**IEEE P802.15 Wireless Personal Area Networks**

Project	IEEE P802.15 Working Group for Wireless Personal Area Networks (WPANs)		
Title	<b>Channel paging for 4g PHY</b>		
Date Submitted	[17 February 2010]		
Source	[Daniel Popa, Hartman Van Wyk] [ITRON] [France]	Voice: [ ] Fax: [ ] E-mail: [ daniel.popa@itron.com, hartman.vanwyk@itron.com ]	
Re:	Draft text contribution for 15.4g		
Abstract	The proposed Channel Paging provides a method for structuring standard and vendor defined PHY modes, with respect to existing 802.15.4-2006 standard channel paging.		
Purpose	Draft text contribution		
Notice	This document has been prepared to assist the IEEE P802.15. It is offered as a basis for discussion and is not binding on the contributing individual(s) or organization(s). The material in this document is subject to change in form and content after further study. The contributor(s) reserve(s) the right to add, amend or withdraw material contained herein.

Figure 22a: The use of the lower 27 bits for channel pages 7 and 8.

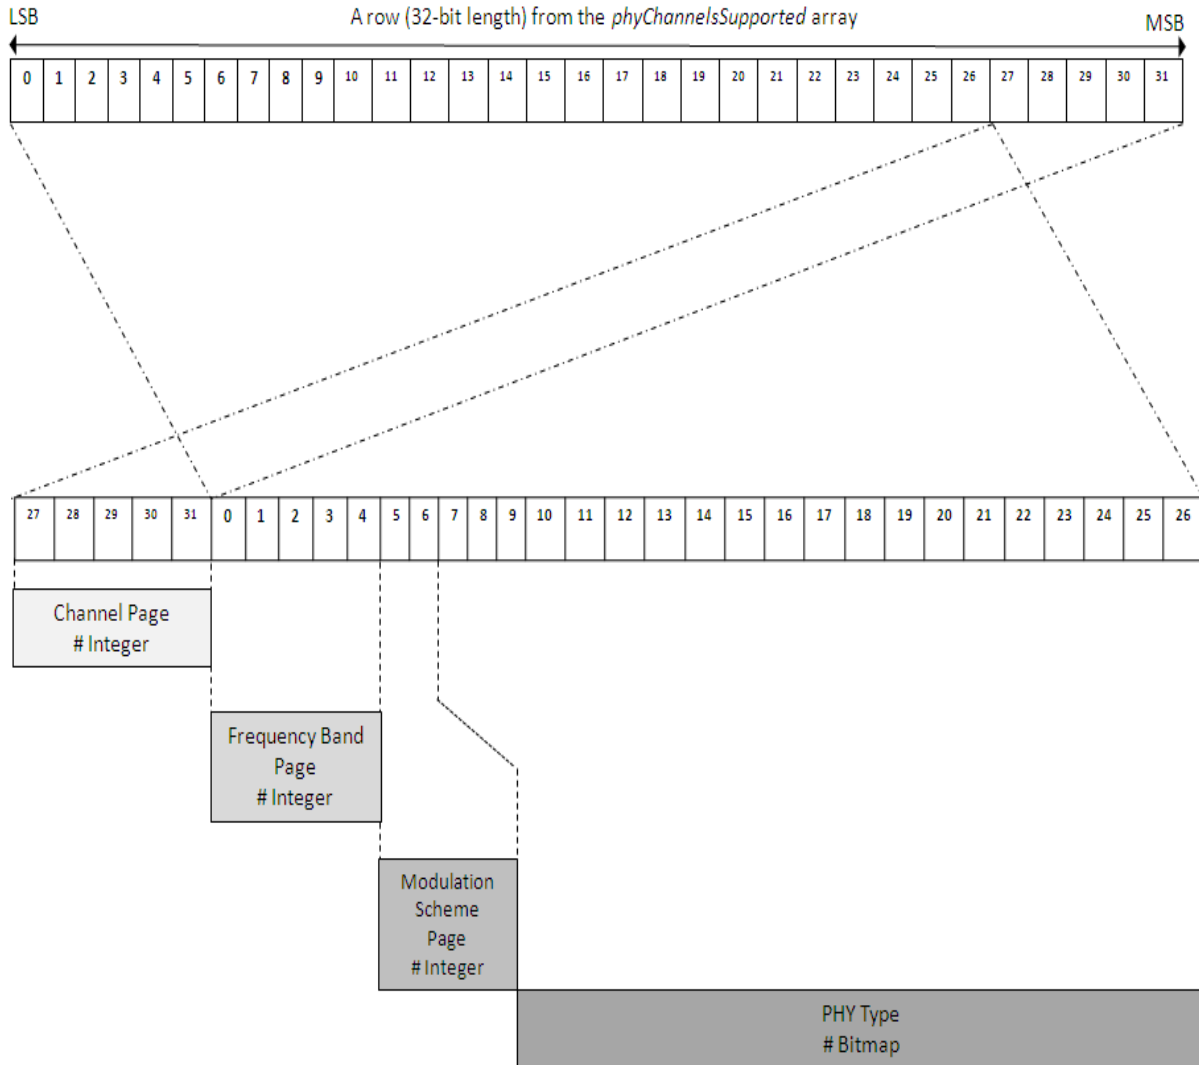
When the upper 5 bits of an element in the PIB attribute *phyChannelsSupported* is equal to 7 or 8, the lower 27 bits (*b0* up to *b26*) shall be used as follows (see also Figure 22a for an illustrative example):

- The first 5 (LSB) bits – ( $b_0, b_1, b_2, b_3, b_4$ ) - shall be used as an integer variable to specify 32 possible standard defined frequency band pages within the channel page 7, as described in 6.1.2.6a.
- The remaining 22 bits – ( $b_5 \dots b_{26}$ ) - shall be used as follows: The first 3 (LSB) bits – ( $b_5, b_6$ ) - shall be used as an integer variable to specify 4 possible standard modulation method pages for each frequency band page, as described in 6.1.2.6b.
- The remaining 20 bits – ( $b_7 \dots b_{26}$ ) - shall be used as a bit mask to specify 20 possible standard PHY Type numbers for each modulation method page, as described in 6.1.2.6c.
